SERVICE BULLETIN

Kit No. 36-4004-1 S Kit No. 36-4004-3 S Kit No. 36-4004-5 S Kit No. 36-4004-7 S
Kit No. 36-4004-9 S Kit No. 36-4004-11 S Kit No. 36-4004-13 S

TITLE: FUSELAGE - WING FORWARD SPAR CARRY-THRU STRUCTURE INSPECTION AND/OR REINFORCEMENT

SYNOPSIS OF CHANGE

Figure 1

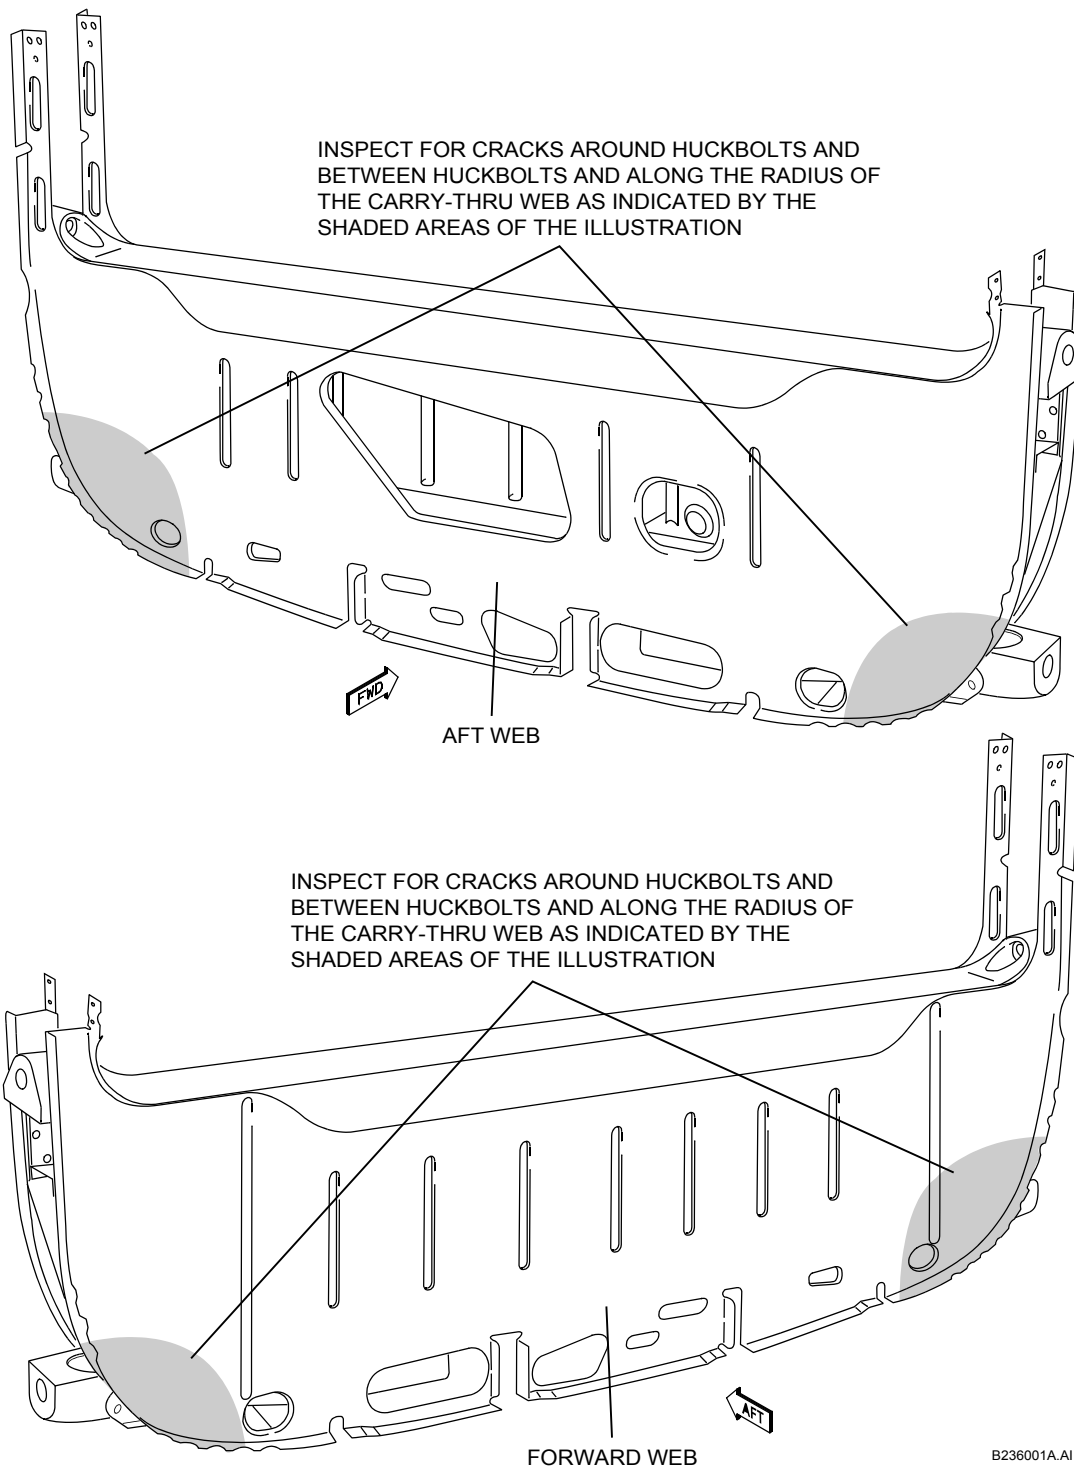
- (2) Remove the pilot's and copilot's seats and the carry-thru cover to obtain access to the front spar carry-thru structure.
- (3) Thoroughly clean the forward and aft frames (webs) of the front spar carry-thru structure in the shaded areas shown in Figure 1.
- (4) Perform a visual inspection of the area cleaned in step 3 for evidence of cracks.
- (5) Perform a dye-penetrant inspection, using visible dyes, of the area cleaned in step 3 for evidence of cracks.

Any of the shaded areas shown in Figure 1 that are modified by the installation of a doubler need not be dye-penetrant inspected until 1500 flight hours after the installation of that particular doubler. If no cracks are found, repeat the inspection every 500 flight hours.

Cracks found in the shaded areas of Figure 1 that have not been modified by a doubler must be repaired as indicated in this Service Bulletin on an individual basis.

The extent of repair is limited to cracking in the radius of the web flange and cracks in the web flat areas at the fasteners of the lower front spar cap.

- (a) For cracks in the bend radius:

- (i) A crack up to 4.0 inches in length shall be stop drilled at the ends using a #30 drill bit. The area is to be repaired per the applicable P/N 36-4004 Kit(s) within the next 100 flight hours, 12 calendar months or the next scheduled inspection whichever occurs first.
- (ii) A crack exceeding 4.0 inches in length shall be repaired PRIOR TO FURTHER FLIGHT per the applicable P/N 36-4004 Kit(s).

- (b) For cracks in the web face, in the area of the huckbolt fasteners:
 - (i) A crack emanating from one fastener in two directions is considered to be one crack. **Do not stop drill, due to the possibility of damaging structure behind web face.**

- (ii) Any crack shall be repaired per the applicable P/N 36-4004 Kit(s), within the next 25 flight hours, 12 calendar months or the next scheduled inspection whichever occurs first.

- (iii) A crack passing through two fasteners and extending beyond for more than 0.5 inch on either end shall be repaired PRIOR TO FURTHER FLIGHT, per the applicable P/N 36-4004 Kit(s).

- (iv) A crack passing through two fasteners and extending beyond for less than 0.5 inch on both ends shall be repaired per the applicable P/N 36-4004 Kit(s), within the next 25 flight hours, 12 calendar months or the next scheduled inspection whichever occurs first.

- (c) If cracks are found in both the forward and aft frames on the same side of the airplane, in either the web face and/or the bend radius, and any of the cracks are more than 1.0 inch long, a repair shall be made PRIOR TO FURTHER FLIGHT.

- (d) If cracks are found in both the forward and aft frames on the same side of the airplane, in either the web face and/or the bend radius, and all of the cracks are less than 1.0 inch long, a repair shall be made per the applicable P/N 36-4004 Kit(s) within the next 25 flight hours, 12 calendar months or the next scheduled inspection whichever occurs first.
